Original Application No. 249 of 2020 (SZ).

**REPORT OF THE JOINT COMMITTEE CONSTITUTED IN THE O.A. NO. 249 OF 2020
IN THE MATTER OF DUSHARLA SATYANARAYANA VS NATIONAL HIGHWAY
AUTHORITY OF INDIA AND OTHERS BEFORE THE HON'BLE NATIONAL GREEN
TRIBUNAL, SOUTHERN ZONE, CHENNAI**

Date: 31.01.2022

1. Existed Culvert below the State Highway & Paddy Fields towards northern FTL area of Chuttukunta as per Irrigation Map.

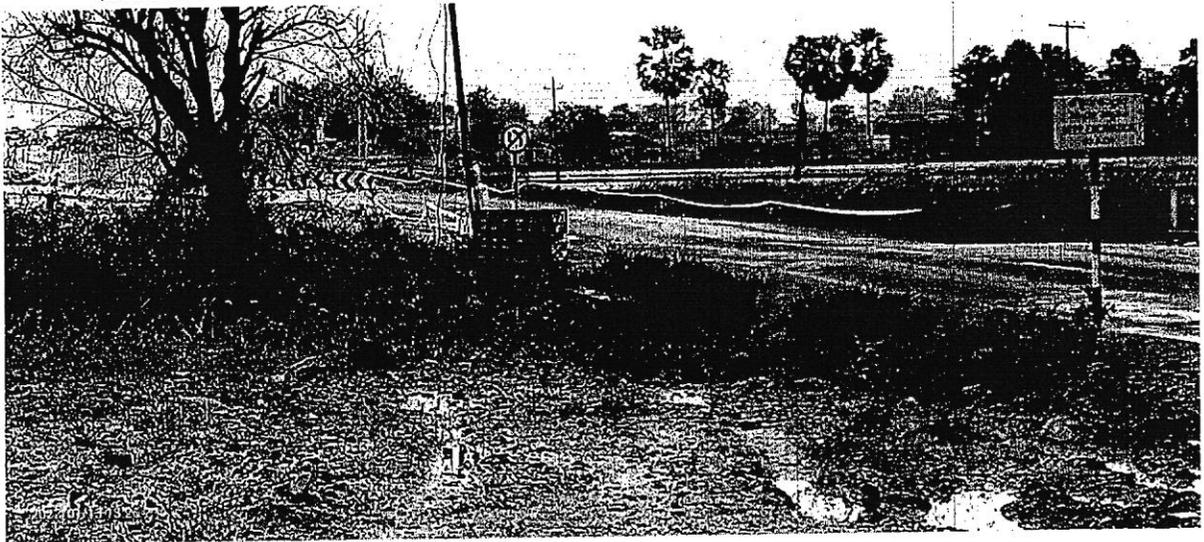
- b. Secondly, a feeder channel flowing from the paddy field is connected to chuttukunta lake through 7.6 meter minor Bridge/Culvert (3.8m with 2 vents) which is passing beneath the State Highway. Presently, this minor bridge/culvert is keeping the flow of water from the feeder channel flowing from the northern FTL area to Chuttukunta Lake. It is submitted that the proposed length of 80m column bridge is longer than existed 7.6 meter minor Bridge/culvert (3.8m with 2 vents). Therefore, the committee is in view that the 80m proposed Column Bridge is sufficient to hold enough water even during peak rainy season, as compared to 7.6m culvert.

3. Starting point of proposed column bridge before the culvert

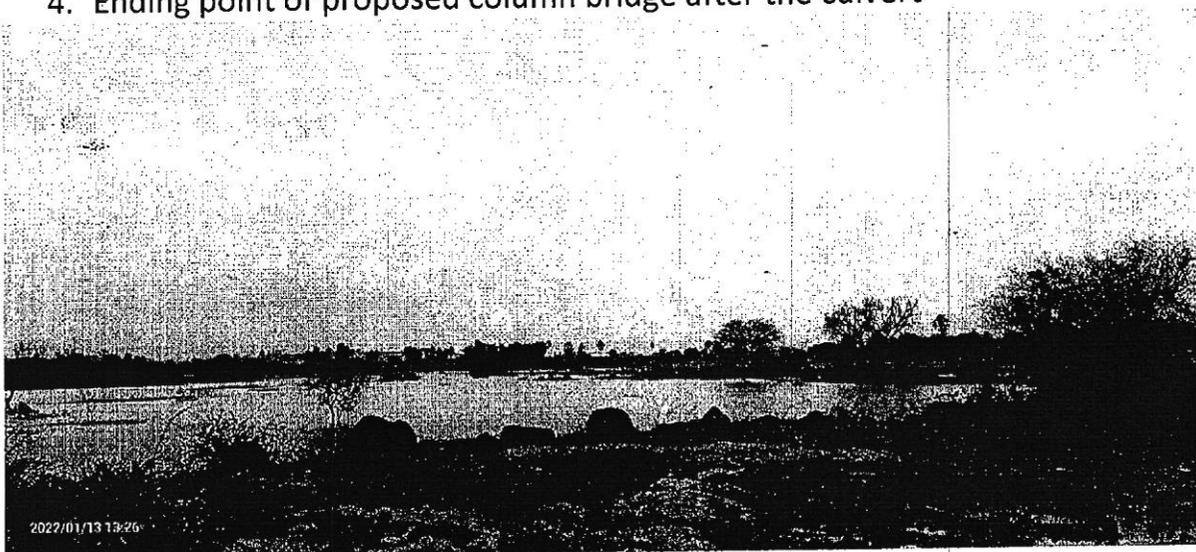
observed. The present FTL of the lake would not be affected due to construction of Column 80m Bridge, instead of direct soil filling. Further, no impact on the flow and requirement of water to the agricultural fields are also observed. Therefore, the committee is in view of that, since there is no alternate alignment is possible, the extension of State Highway is planned on the old alignment. The impact of the equilibrium of the lake may be minimized by the construction of 80m Column Bridge, instead of direct soil filing.

Prayer: Keeping the above facts and circumstances, the committee is view that as proposed by Joint Committee in the previous report, **80m Column Bridge is sufficient, instead of 370m Column Bridge** to keep the flow of water during the peak rainy season and to conserve the ecology of Chuttukunta Lake. The project authority shall not take any additional area inside the water body for construction of bridge, as they proposed during joint committee visit. Keeping view of the above, it is prayed that the Hon'ble NGT may take appropriate action as deemed fit.
